Customer : CU-DAR001 Dart Helicopters Services	Drawing Name : HELI UTILITY BASKET LH/RH 350/355
Job Number : 30002	
Estimate Number : 10208	
P.O. Number : N/A	Part Number : D350607043
This Issue : 12/20/2006 S.O. No. : N/A	Drawing Number : D350-607 REV F P7-9
Prsht Rev. : NC	Project Number : N/A
First Issue : N/A Type : LARGE FAB ASSY	Drawing Revision : F
Previous Run : 29128	Material : N/A
Written By : <i>[Signature]</i>	Due Date : 1/15/2007 Qty: 1 Um: Each
Checked & Approved By : <i>[Signature]</i> 061220	
Comment : Est Rev:E as Per DSI9318 06-01-24 JLM

DESIGN <i>CP</i>	DRAWN BY <i>CP</i>	DART AEROSPACE LTD HAWKESBURY, ONTARIO, CANADA	
CHECKED <i>[Signature]</i>	APPROVED <i>[Signature]</i>	DRAWING NO. DSI 9318	REV. A SHEET 1 OF 1
DATE 06.01.06		TITLE WASHER ADDITION	SCALE NTS
A	06.01.06	NEW ISSUE

DART SERVICE INSTRUCTION

TO AMEND INSTALLATION INSTRUCTIONS D350-607 REV. F

Figure 5- Basket Replacement Parts
(D350-607-043 Heli-Utility-Basket™)

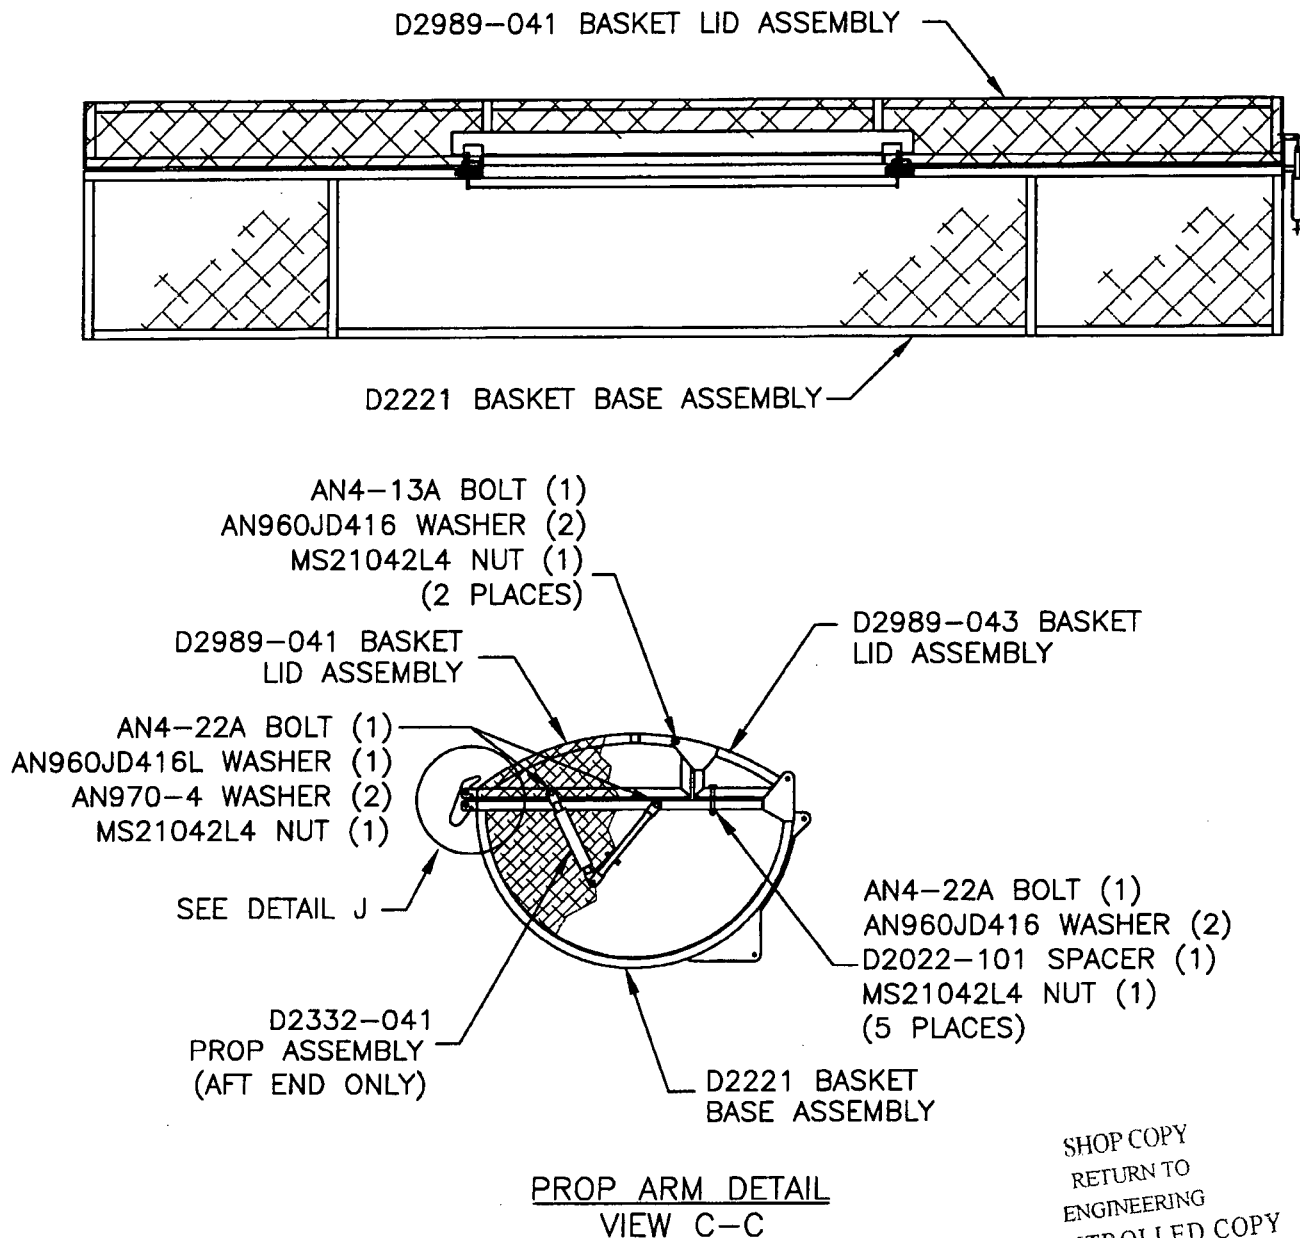
The corrected bolt stackup from Figure 5 of installation instructions D350-607 Rev. F is given below:

AN4-13A BOLT (1)
AN960JD416 WASHER (1)
HINGE PLATE (REF)
NAS1515H4 WASHER (1)
BASKET FRAME (REF)
AN960JD416 WASHER (1)
MS21042L4 NUT (1)
(2 PLACES)

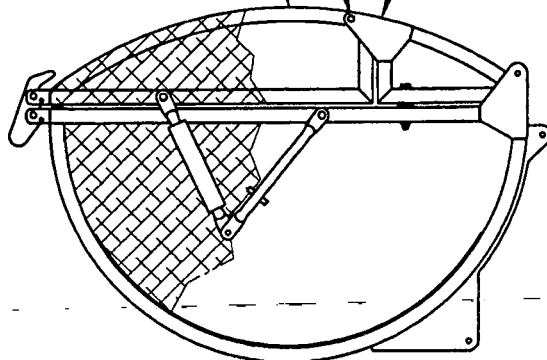
To reduce the possibility of damaging the finish, a **NAS1515H4** washer (2 places) has been added between the hinge plate and basket frame on the **D350-607-043/-047 Heli-Utility-Basket**.
